PLANNING COMMISSION MEETING

April 4, 2024 - 6:00 PM
City Hall Council Chambers

To: Planning Commission
From: Kris Jenson, Planning Manager
Date: March 27, 2024
Subject: Packet Material for the April 4, 2024 Planning Commission Meeting
Agenda Item: Autumn Hill preliminary plat
Action Deadline: May 15, 2024

LANDSCAPE PLAN

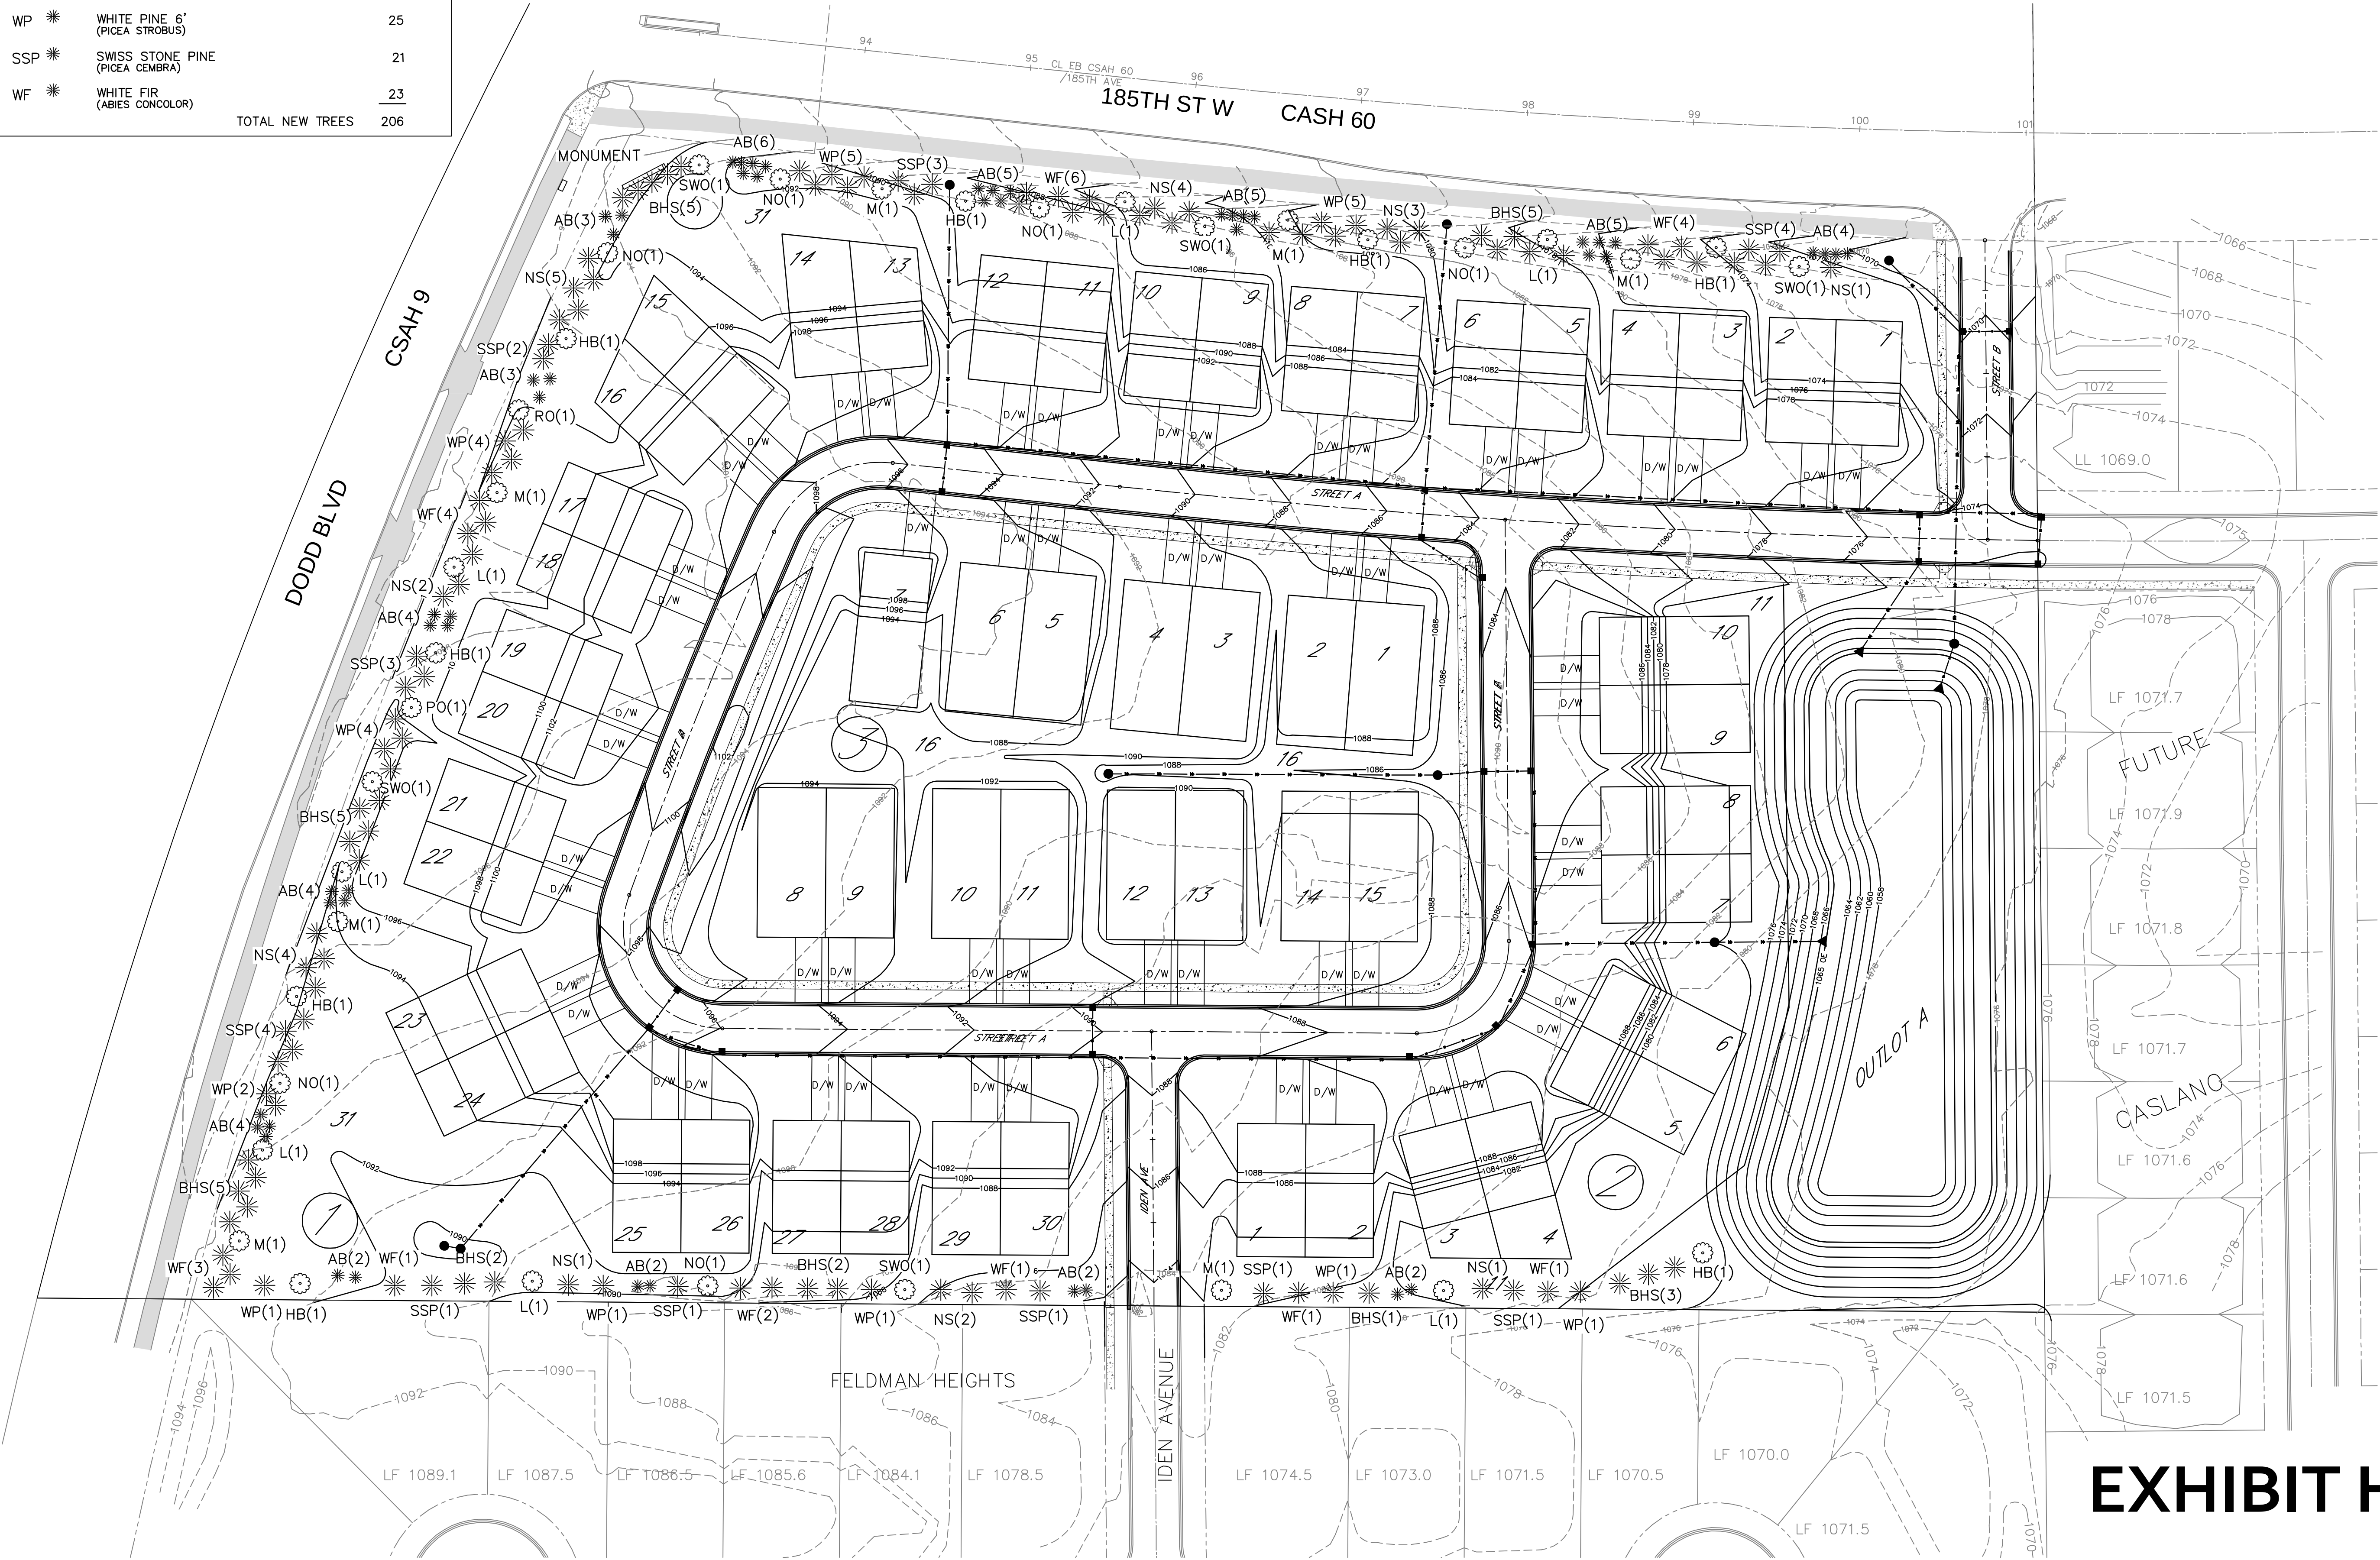
Landscaping. Landscaping is proposed along the south property line, as required in Section 11-57.19, and is a mix of overstory and evergreen trees (Exhibit H). In addition, each townhome building must provide landscaping at the immediate perimeter of the unit (Exhibit I). The landscape plan must be revised to include a combination of overstory

trees, understory trees, evergreens, shrubs, etc. across the site and not just along the perimeter. The typical foundation planting plan must be revised to show landscaping around the immediate perimeter of the principal structure, and not just at the front of the unit. These revised plans must be submitted prior to City Council consideration of the preliminary plat. All landscaped areas, including common open space and public right of way, must have an inground irrigation system with an automatic controller. With the final plat, the Developer must provide information that the landscaping of the detached townhome units meets the requirements of Section 11-57-19.G.

6. Within Lot 31, Block 1, the Developer must install sod with the buffer yard plantings to the trails along 185th Street and Dodd Boulevard.
7. Prior to City Council consideration, the landscape plan must be modified to include a combination of overstory, understory, evergreens and shrubs across the site and to incorporate the 12 spruce trees indicated as save trees on the tree inventory plan.
